Subject: 2015 Heap Leach Organics Stockpile Location and Trail Reroute

Fairbanks Gold Mining, Inc. (FGMI) is requesting a modification to our Plan of Operations for the Fort Knox gold Mine. This modification includes a proposed location to stockpile organics from the remaining heap leach construction. There are approximately 44,000 cy of organics that needs to be stockpiled before 2015 Stage 5 construction of the heap leach pad can start. The proposed organics stockpile will accommodate an additional 135,000 cy. The current organics stockpile, Dump 4, on the attached figure is maxed out.

Trail Reroute
 HL Growth Media
 Date: January 2015

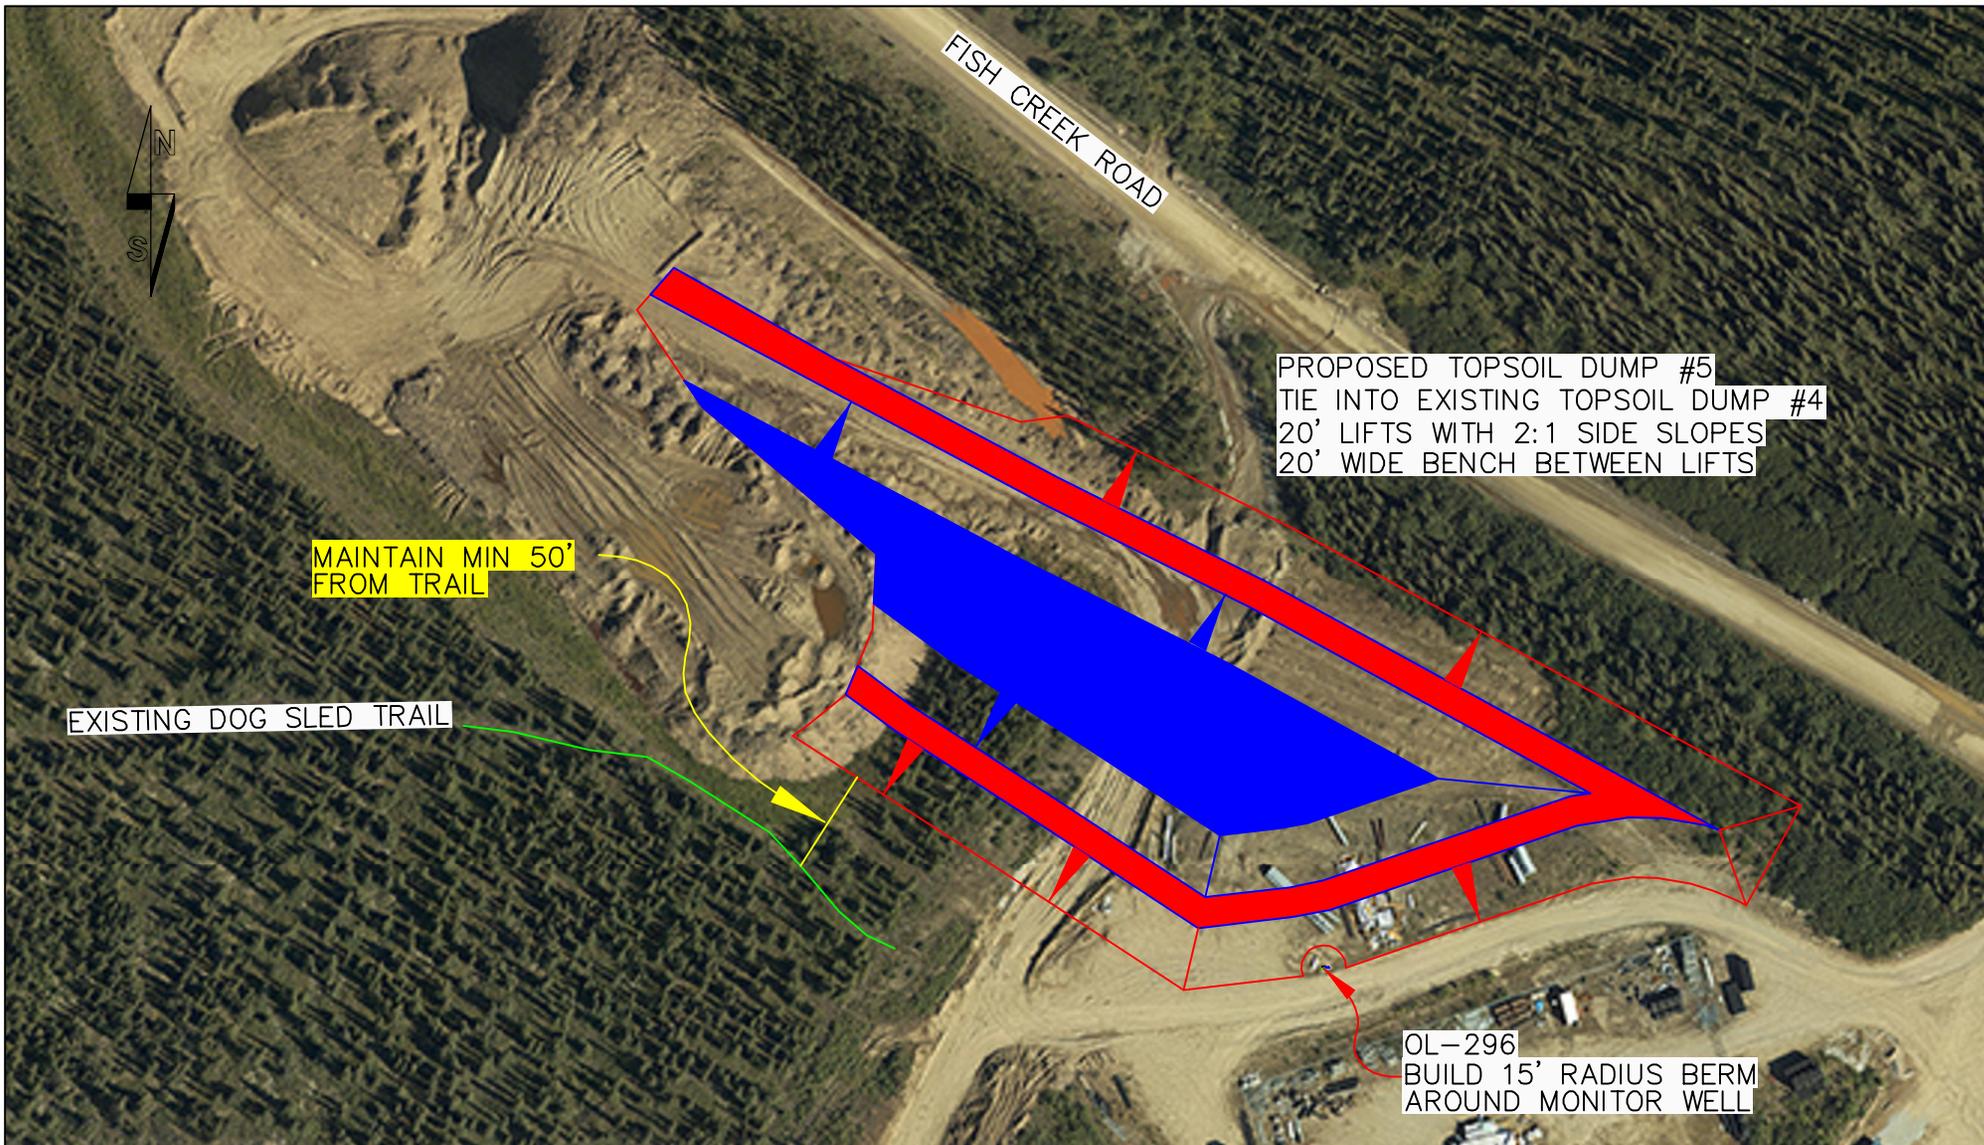
There is an existing trail that will be covered by the new organics stockpile. We have worked with the trail users in identifying a new connection to the trail system. The trail will be installed utilizing an IronWolf tree mulcher. The trail will be cleared down to the vegetative mat, there will not be a cut and fill volume.

HEAP LEACH
PROPOSED TOPSOIL DUMP #5

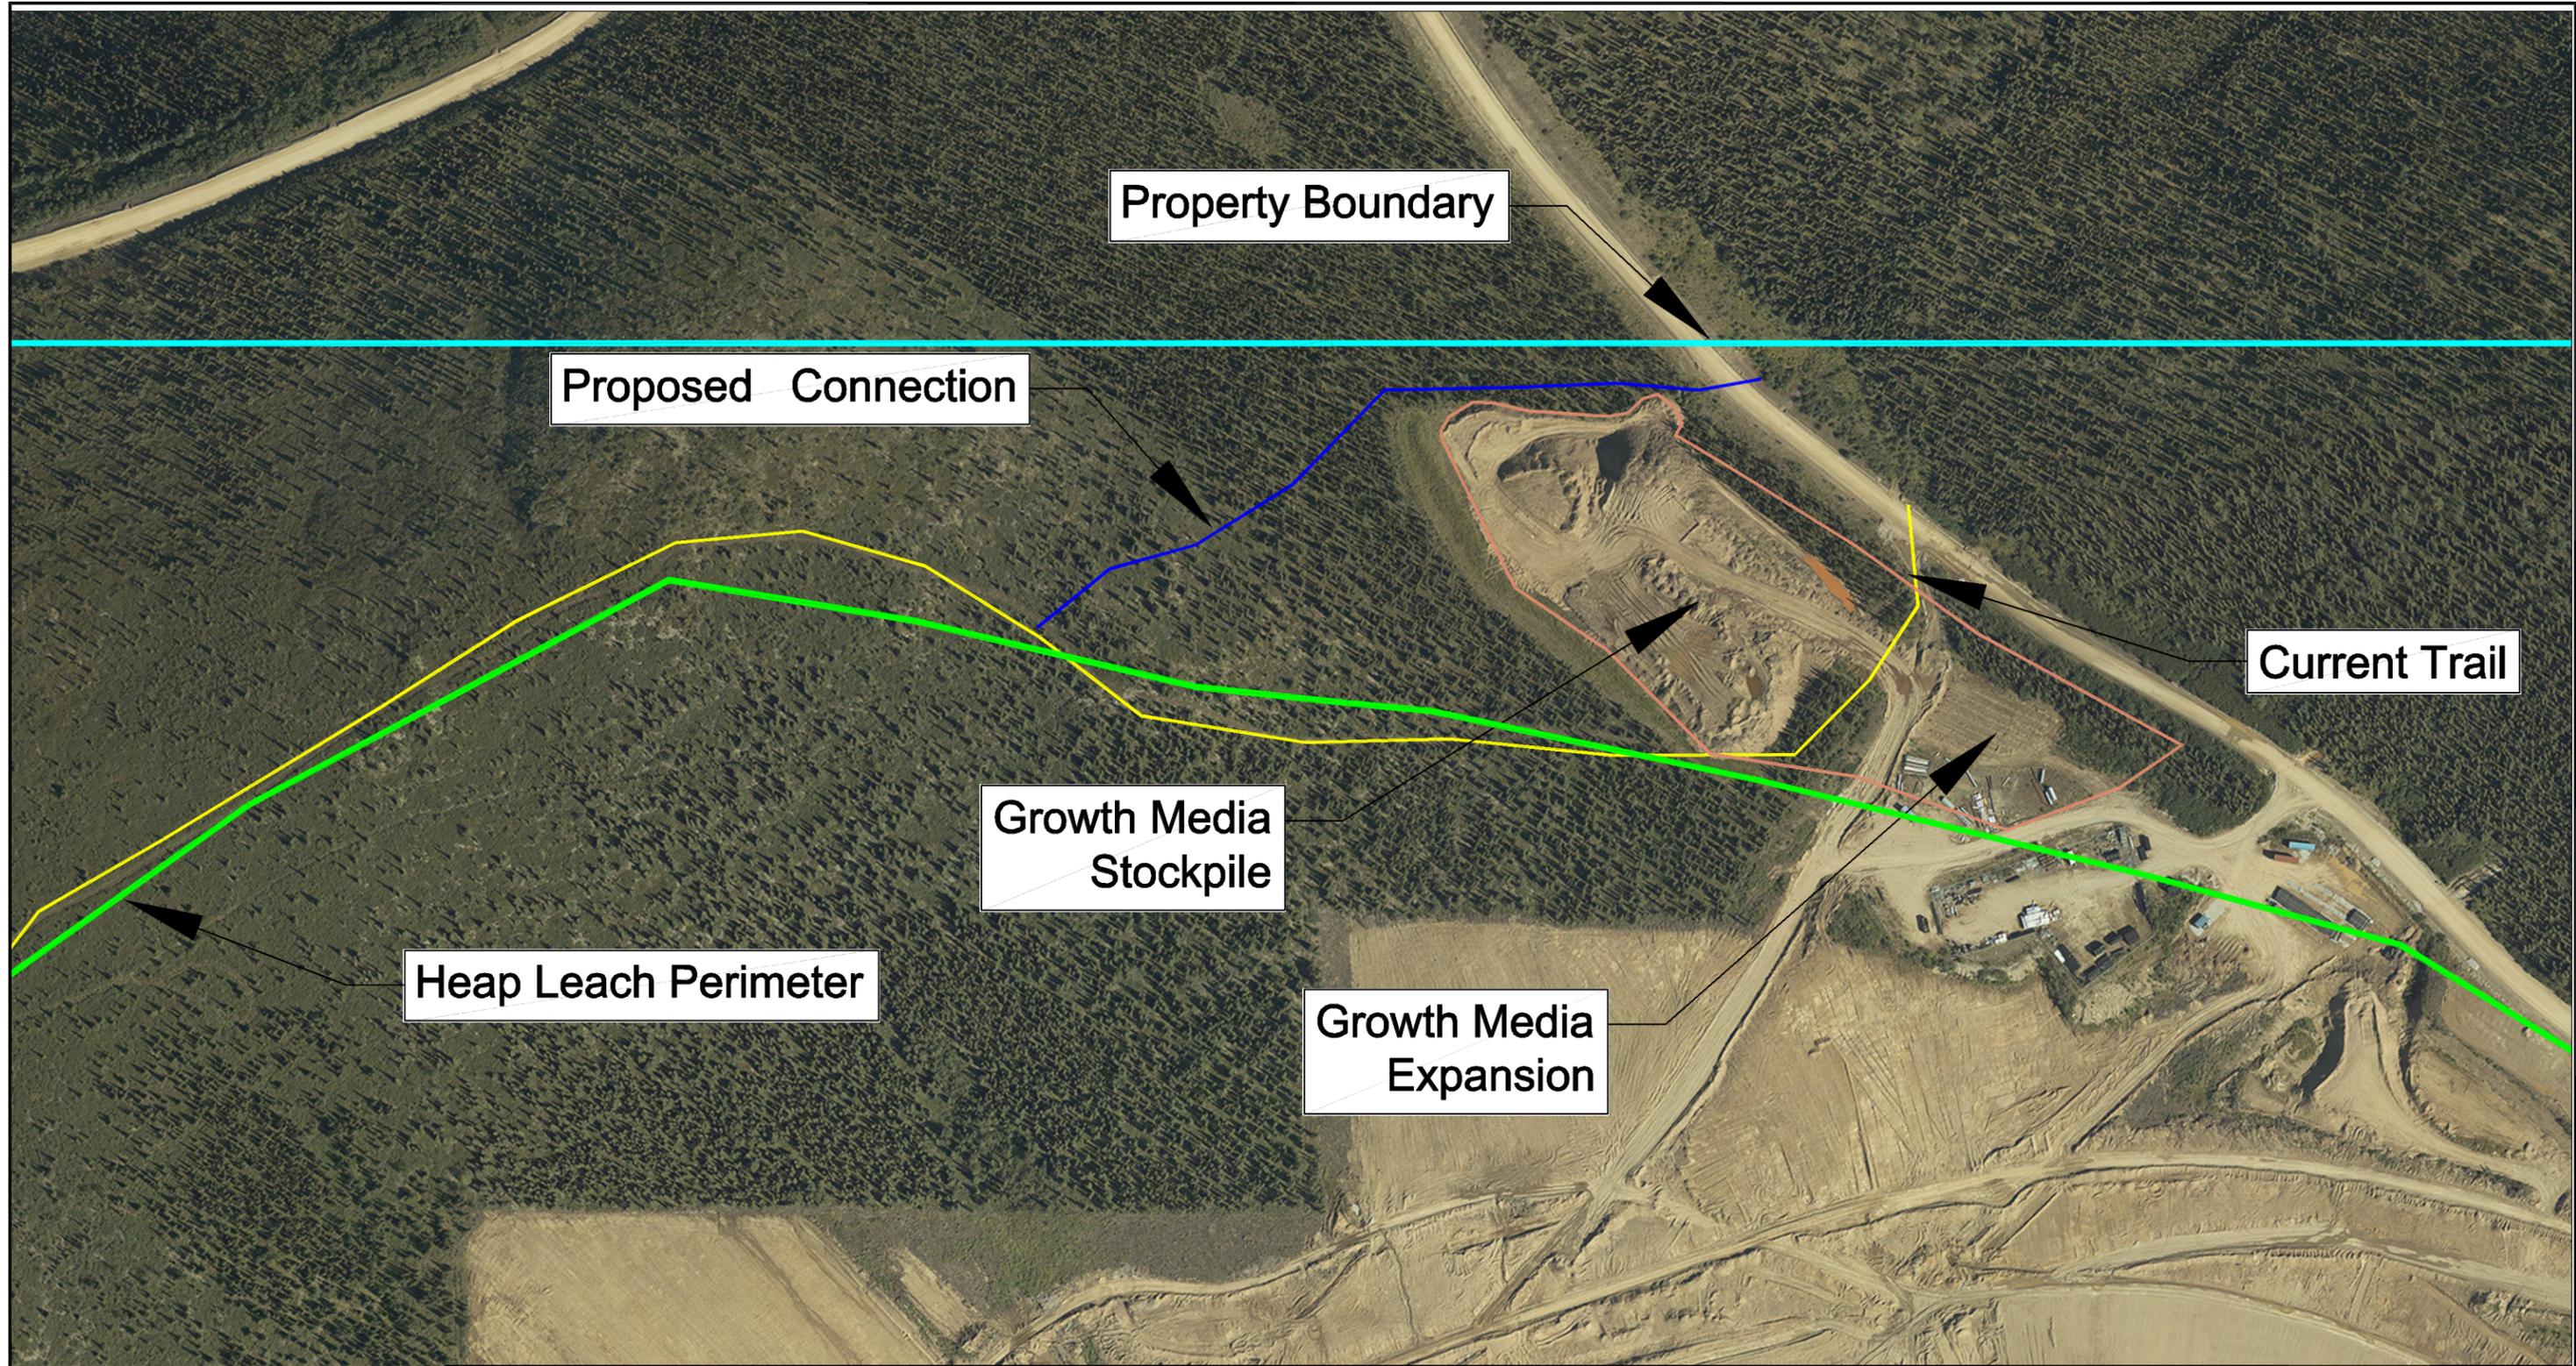
COMMENTS:
1st LIFT APPROX. 100,000 CY
2ND LIFT APPROX. 35,000 CY
